INCH-POUND
MIL-C-39012C
AMENDMENT 3
5 December 1988
SUPERSEDING
AMENDMENT 2
26 February 1986

CONNECTORS, COAXIAL, RADIO FREQUENCY,
GENERAL SPECIFICATION FOR

This amendment forms a part of MIL-C-39012, dated 11 August 1982, and is approved for use by all Departments and Agencies of the Department of Defense.

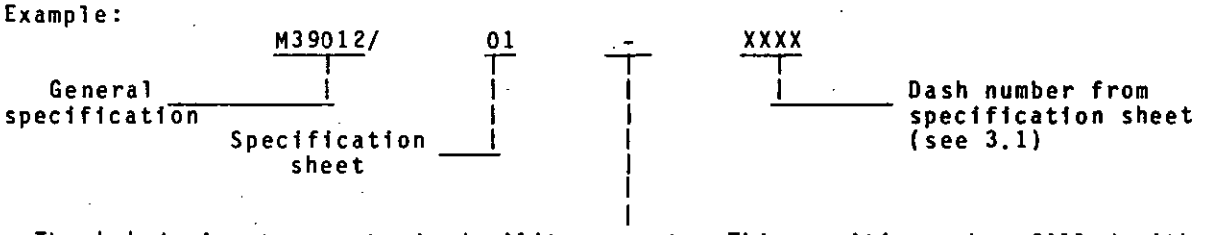
* 1.2.3, delete and substitute:

"1.2.3 Part number. The part number shall consist of the letter 'M' followed by the basic specification sheet number, and a sequentially assigned four digit dash number. The first digit in the dash number designates the material of the connector body (shell); i.e., '0' for brass, '3' for corrosion-resistant steel; and '4' for copper beryllium.

The '-' designates a standard military part. This position, when filled with the letter 'B' (i.e. M39012/01BXXXX), signifies a military part which is for OEM use only. The part is assembled to the cable with special tooling. Acquisition of this type part by any agency other than OEM's is prohibited and will result in the substitution of the equivalent military replacement part (i.e., if 'M39012/01BXXXX' is submitted for acquisition, 'M39012/01-XXXX' will be recommended)."

FIGURE 6. Safety wire hole pullout procedure.

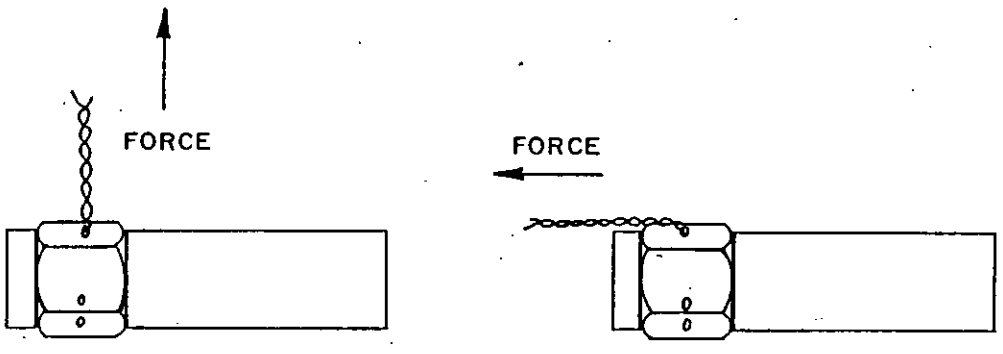
* Add figure 6 as follows:

"4.6.25 Safety wire hole pullout (see 3.32). A single strand of safety wire shall be looped through the safety wire hole and secured to itself. Forces of 15 pounds (67 newtons) minimum shall be applied to the safety wire pulling away from the connector. One pull shall be parallel to the connector axis and one pull perpendicular to the connector axis (see figure 6). The safety wire shall be corrosion resistant steel .020 inch diameter (24 gauge) or .015 inch diameter, (27 gauge) in accordance with MS20995. This test is to be conducted under static conditions. All holes are to be tested individually."
